Drainage Report Final_V1.pdf Markup Summary

FINAL DRAINAGE REPORT
FOR
LOT 5 OF CLEARWAY **FILING NO. 2**
EL PASO COUNTY, COLORADO

PCD Project No. SF-XX-XXX

DETENTION BASIN OUTLET STRUCTURE DESIGN

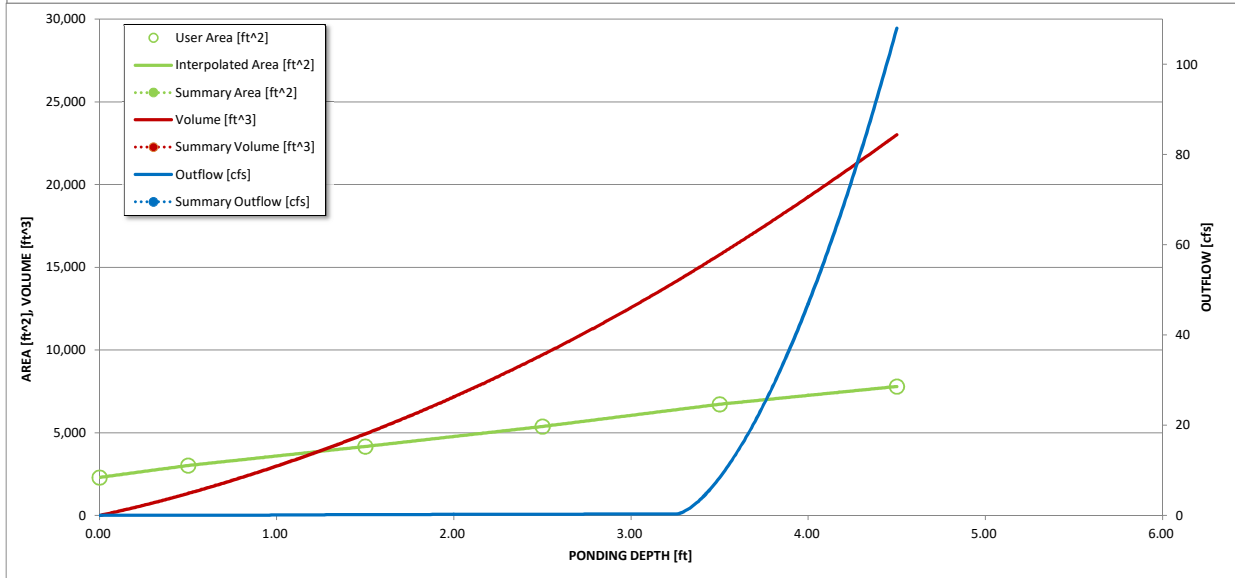
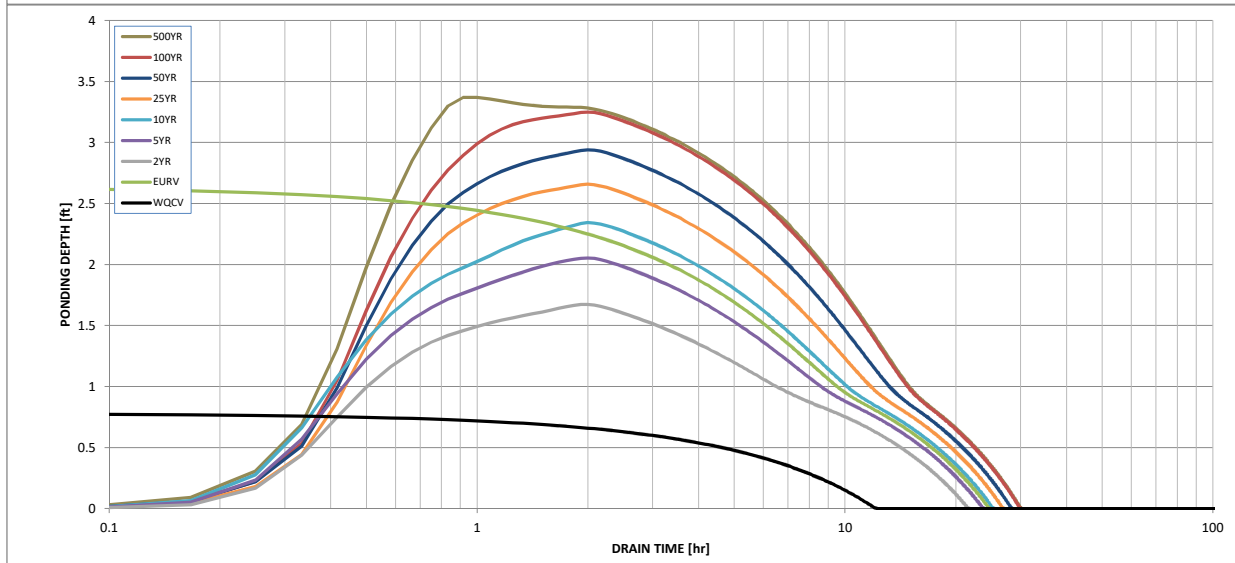
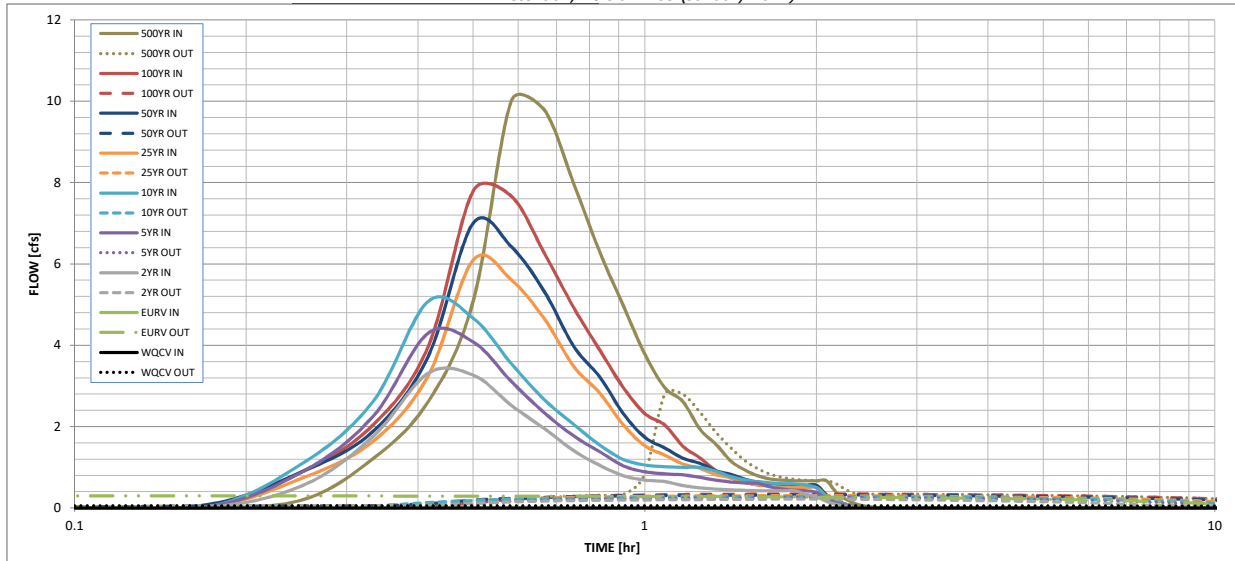
this will cause clogging maintenance issues, consider adjusting restrictor plate height

does not appear to match the plans. revise accordingly

EXISTING DRAINAGE MAP

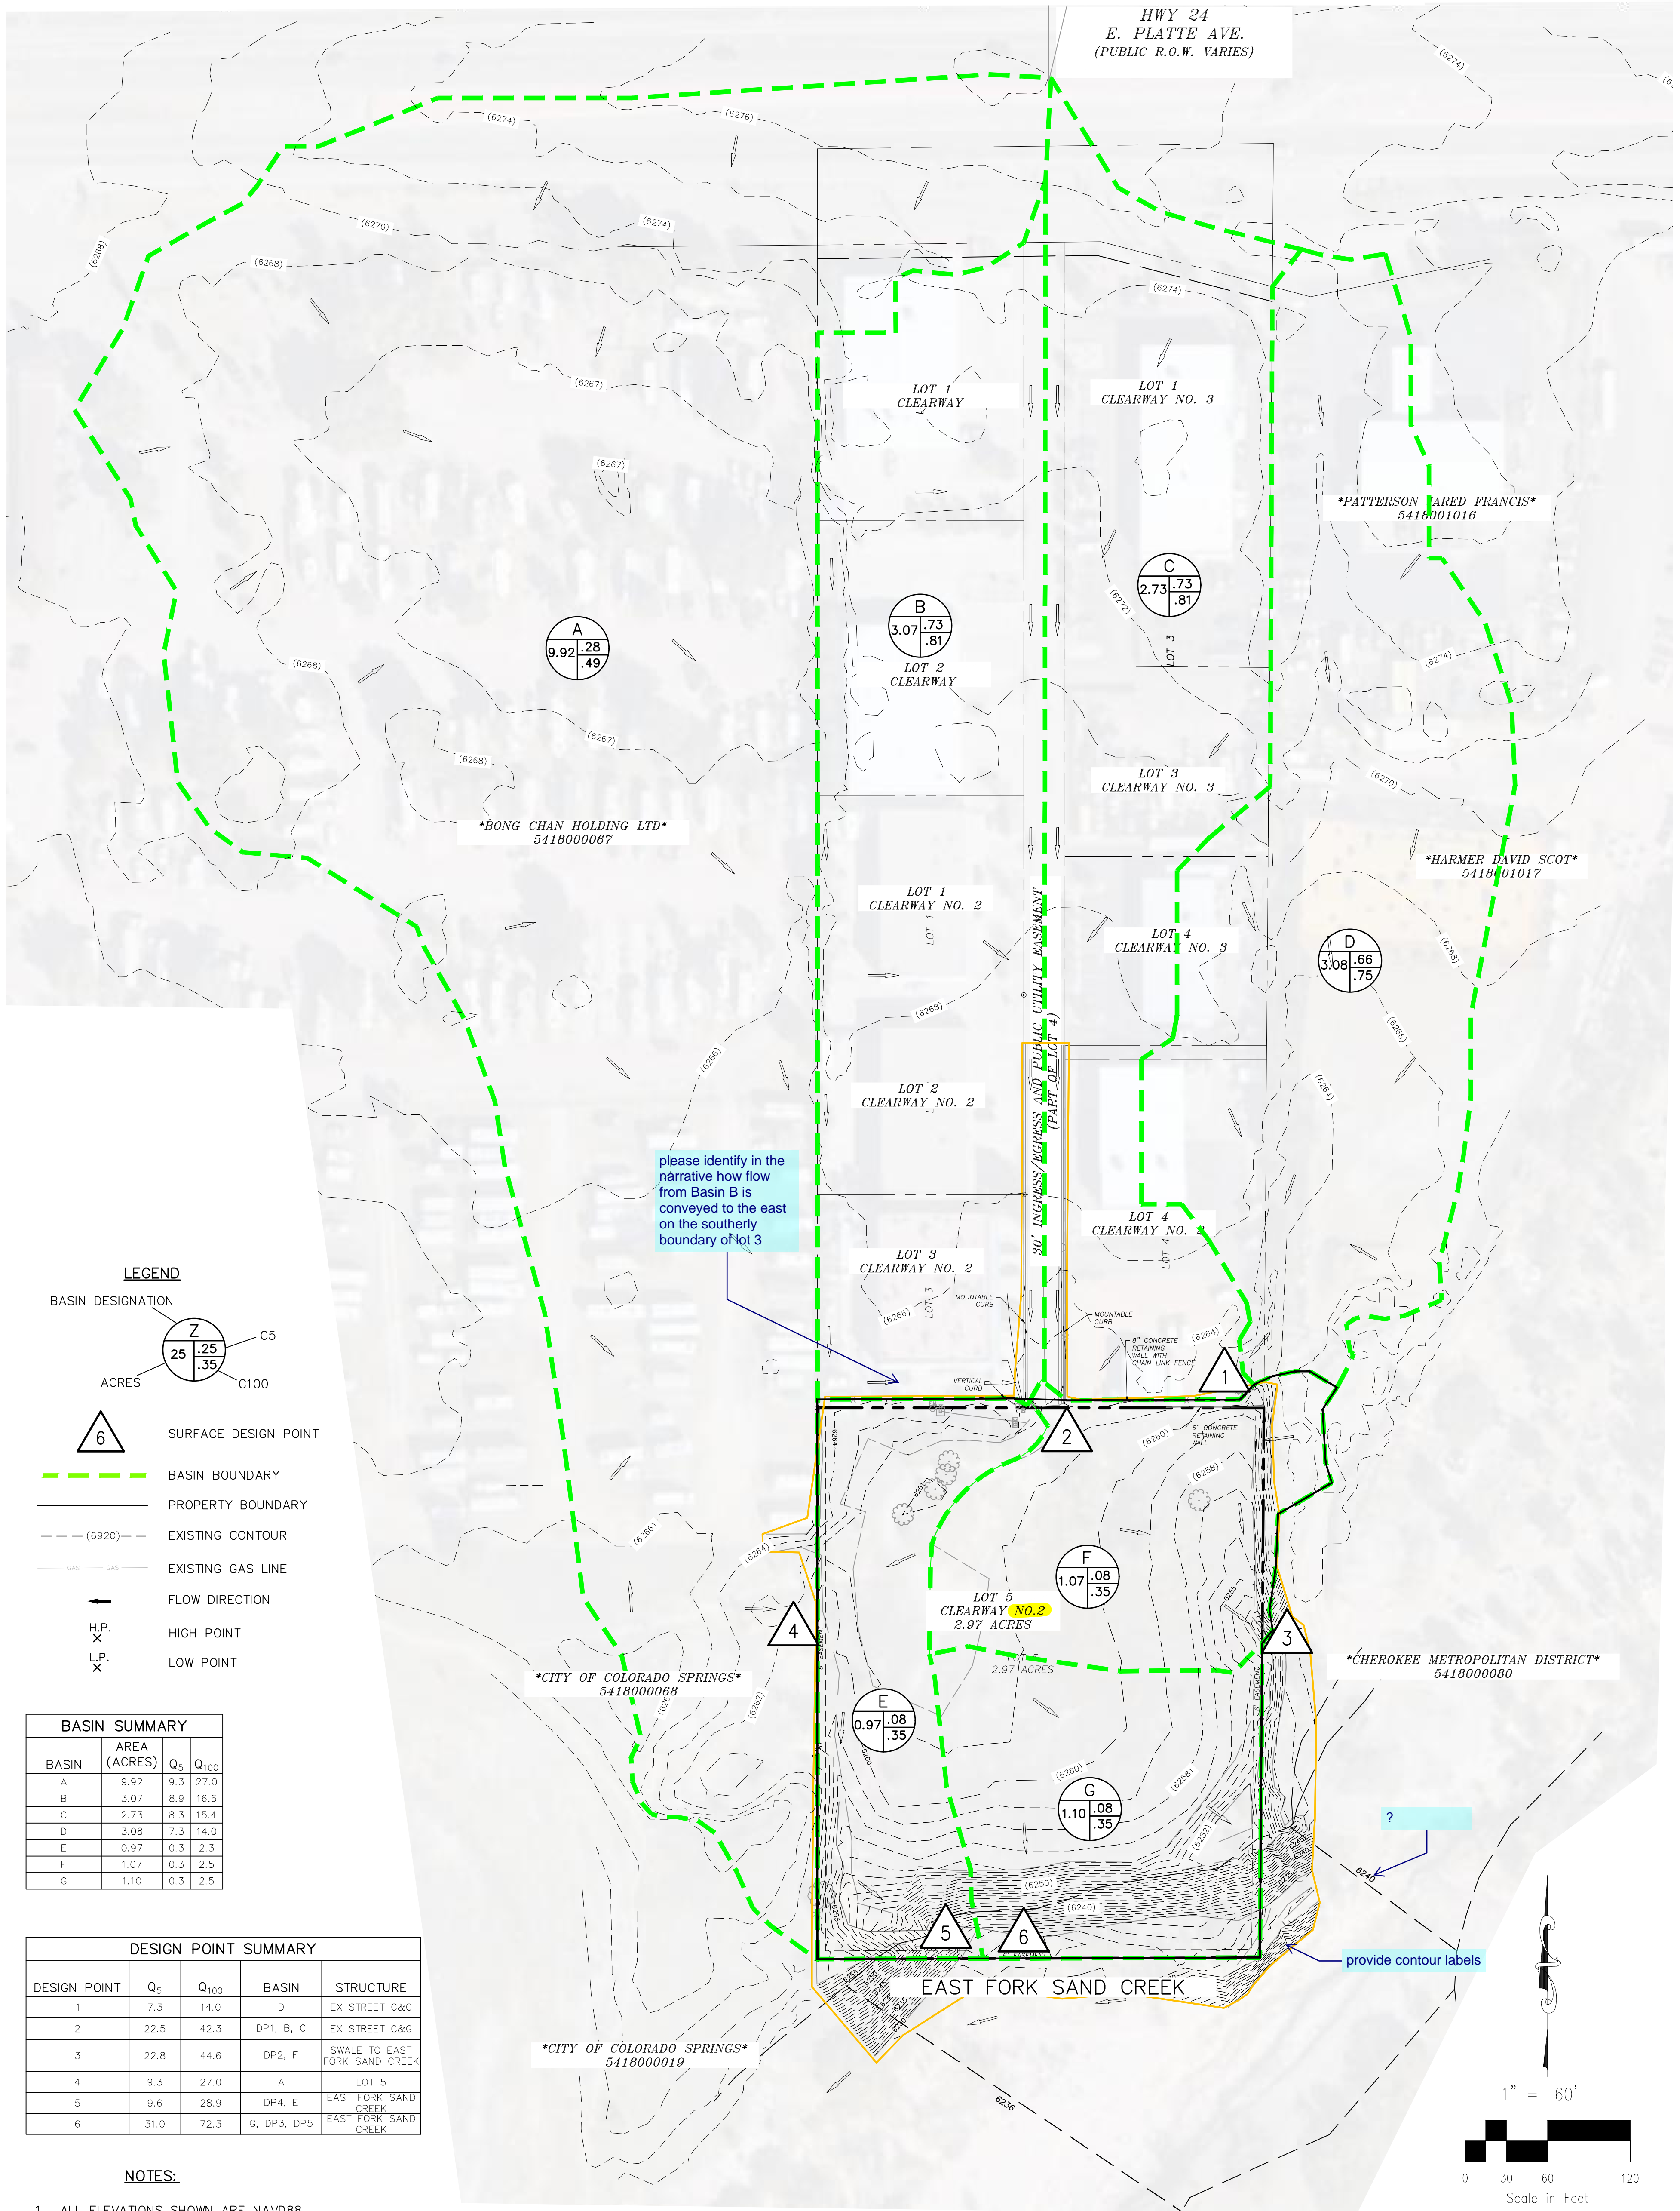
?

please identify in the narrative how flow from Basin B is conveyed to the east on the southerly boundary of lot 3

provide contour labels

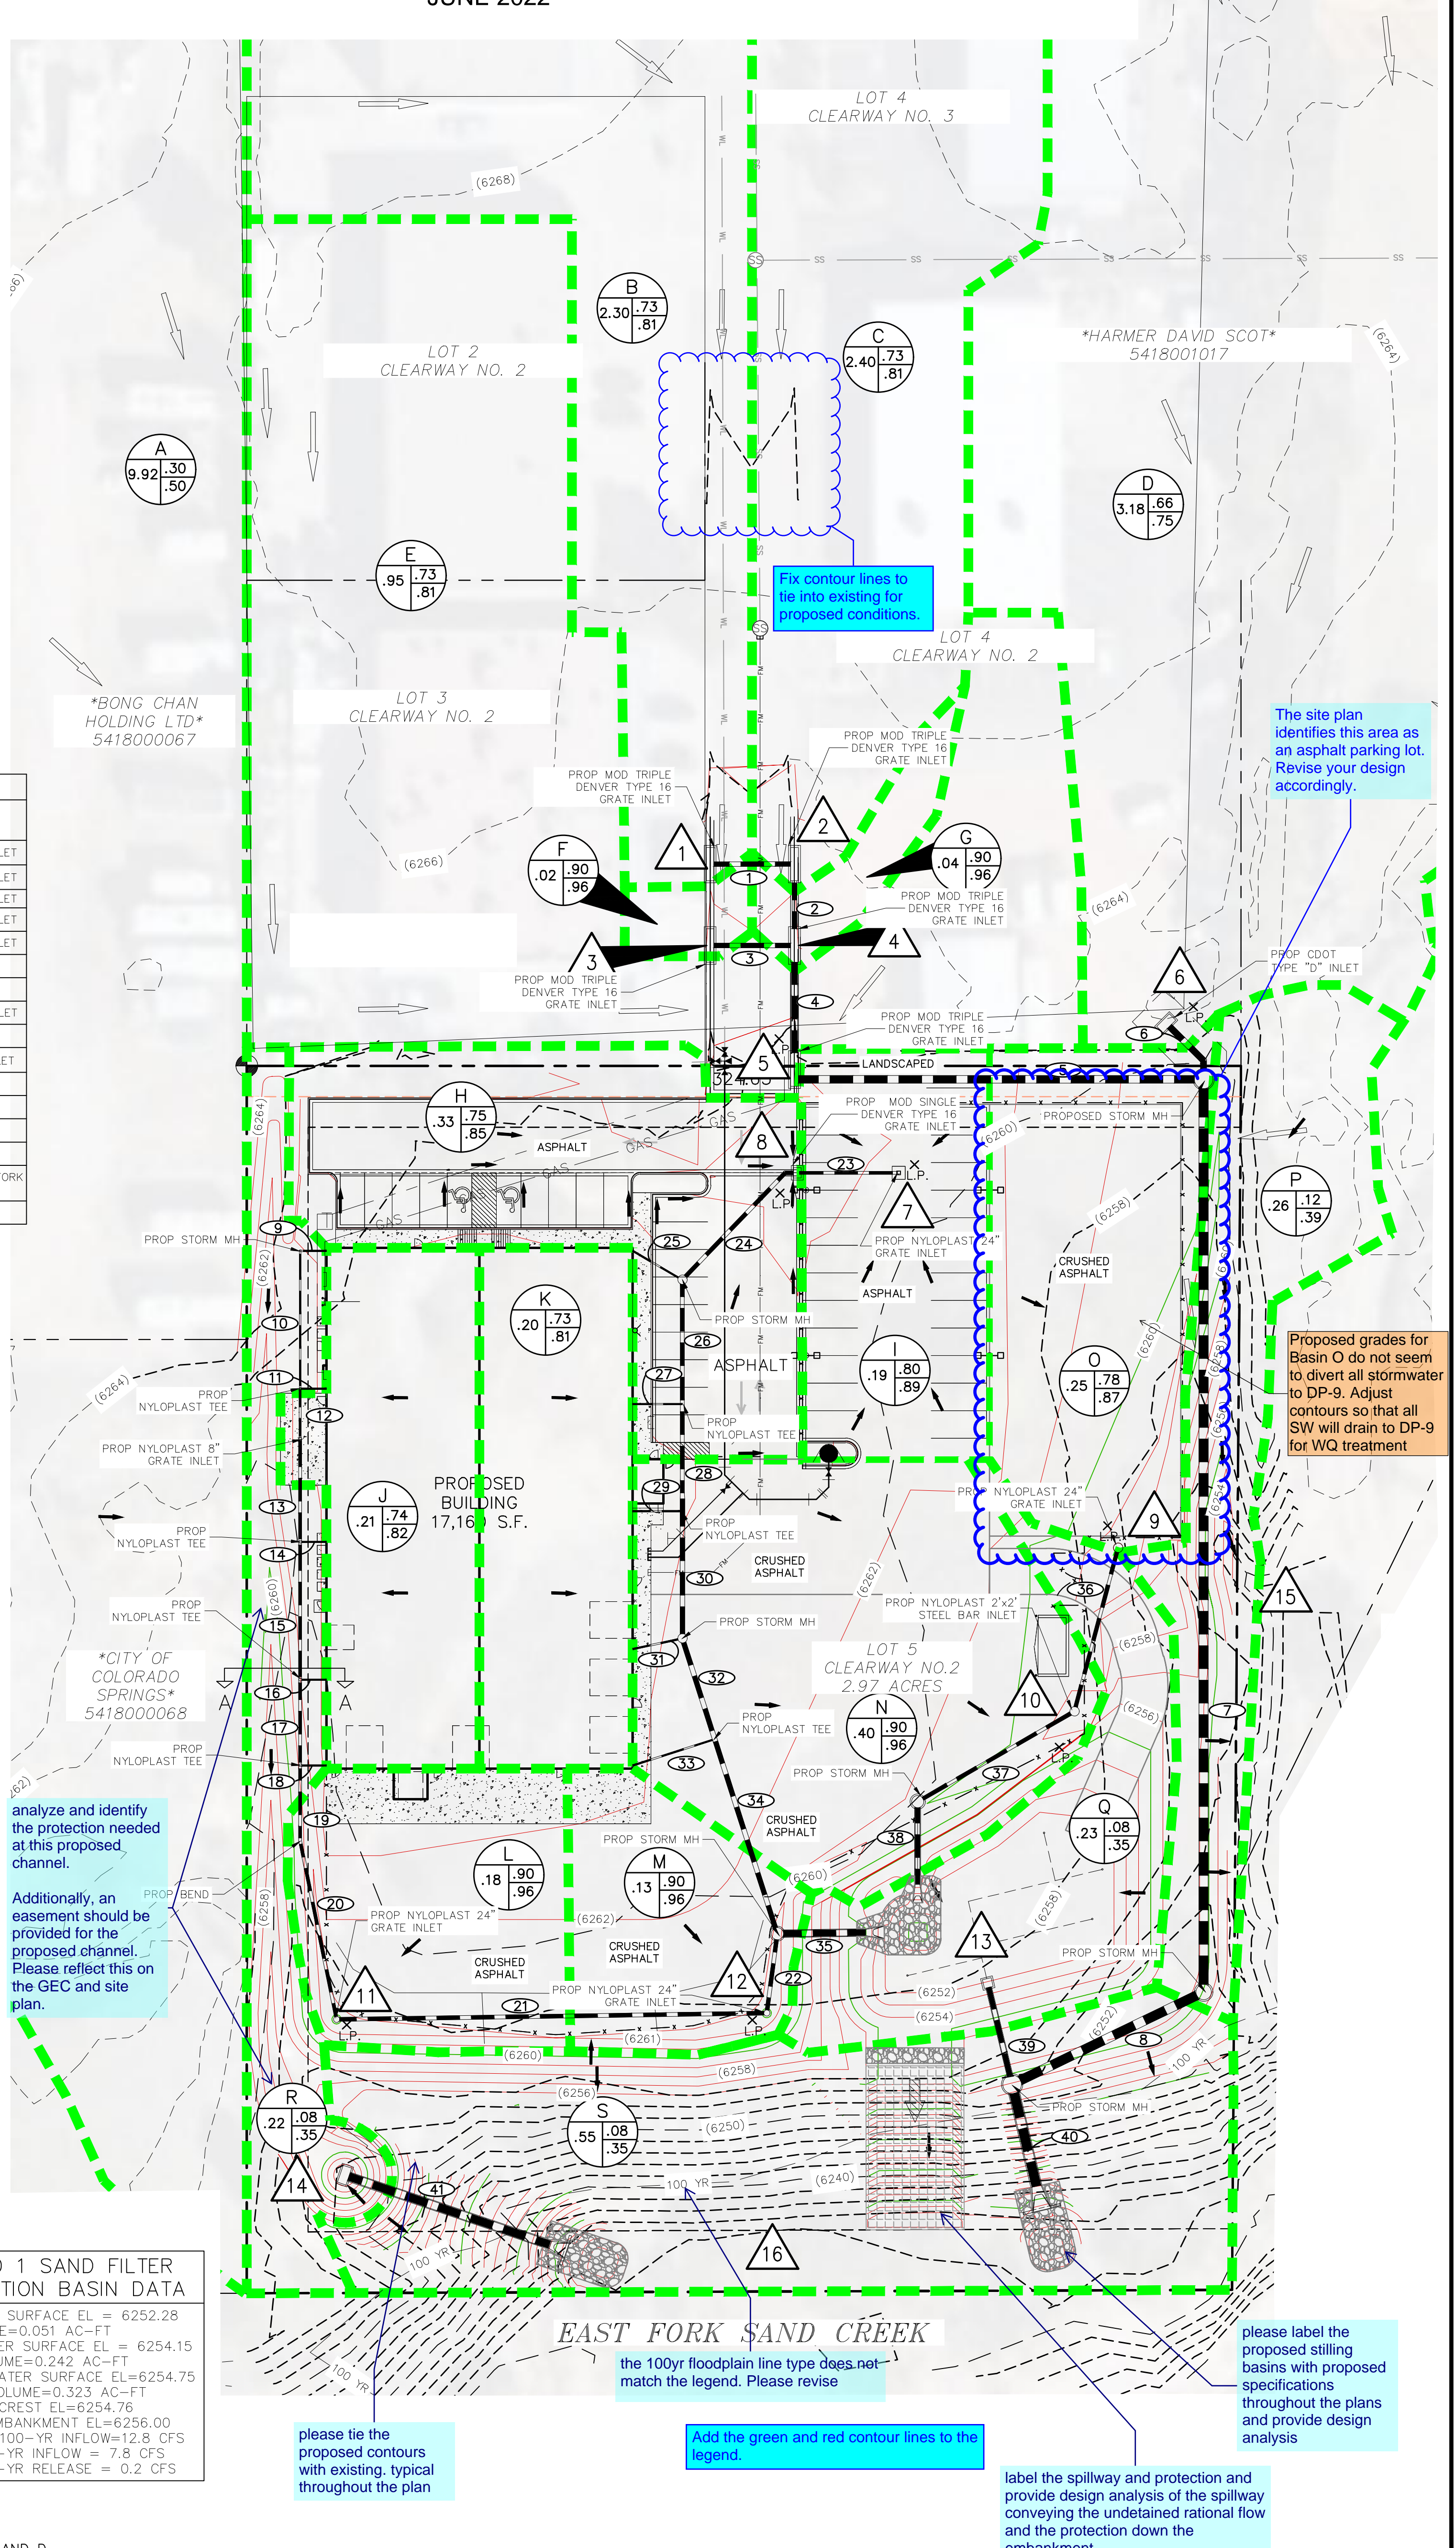
Fix contour lines to tie into existing for proposed conditions.

Label the size of all inlets and stormpipe on the plan.

Add the green and red contour lines to the legend.

The site plan identifies this area as an asphalt parking lot. Revise your design accordingly.

the 100yr floodplain line type does not match the legend. Please revise

analyze and identify the protection needed at this proposed channel.

Additionally, an easement should be provided for the proposed channel. Please reflect this on the GEC and site plan.

label the spillway and protection and provide design analysis of the spillway conveying the undetained rational flow and the protection down the embankment

please tie the proposed contours with existing. typical throughout the plan

please label the proposed stilling basins with proposed specifications throughout the plans and provide design analysis

Proposed grades for Basin O do not seem to divert all stormwater to DP-9. Adjust contours so that all SW will drain to DP-9 for WQ treatment
